Subject: CLUNKING NOISE FROM REAR SUSPENSION WHEN DRIVING OVER ROAD SLOPE / BUMP	Bulletin No: 02-011/16
	Last Issued: 07/20/2016

2016 MX-5 vehicles with VINs lower than JM1ND*****411025 (produced before February 4, 2016)

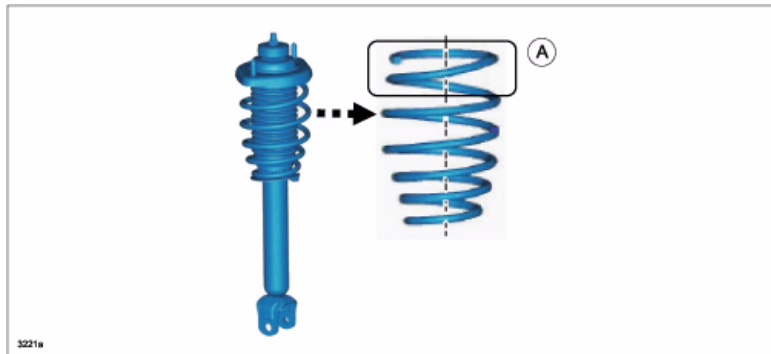
Some vehicles may exhibit a clunking noise from the rear suspensions when driving over road slopes or bumps. This concern may be caused by the top two windings of the rear shock absorber coil spring (A) interfering with one another and causing a stick-slip noise.

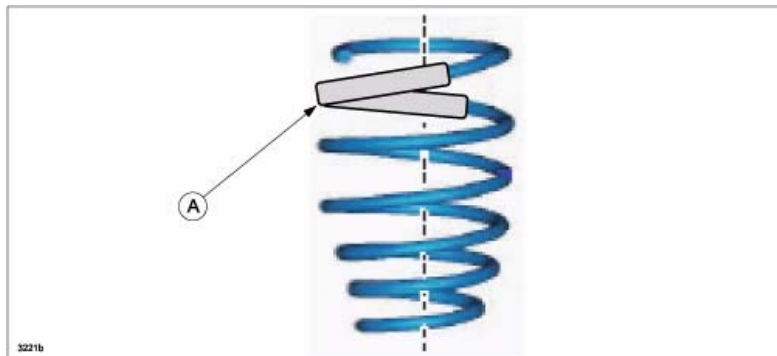
To correct the concern, a resin protector (A) has been installed onto the coil spring.

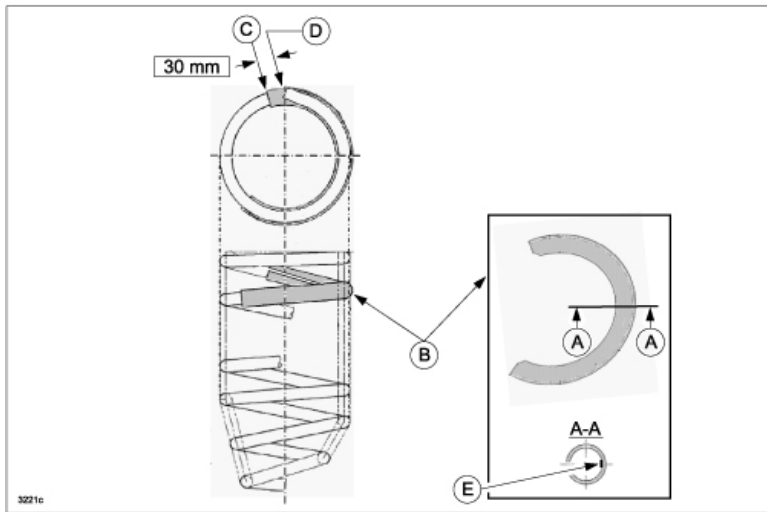
1. Verify customer concern.
2. Install the protector onto the coil spring on both sides.
 - a. Remove the coil spring on both sides according to the instructions on MS3 online (REAR SHOCK ABSORBER AND COIL SPRING DISASSEMBLY/ASSEMBLY).
 - b. Degrease the top two windings of the spring.
 - c. Install the protector (B) onto the coil spring starting from approximately 30 mm away (C) from the spring top end (D) as shown below.

NOTE: The inner side of the protector contains adhesive glue (E). After installation, press on the protector to make sure it adheres to the spring.
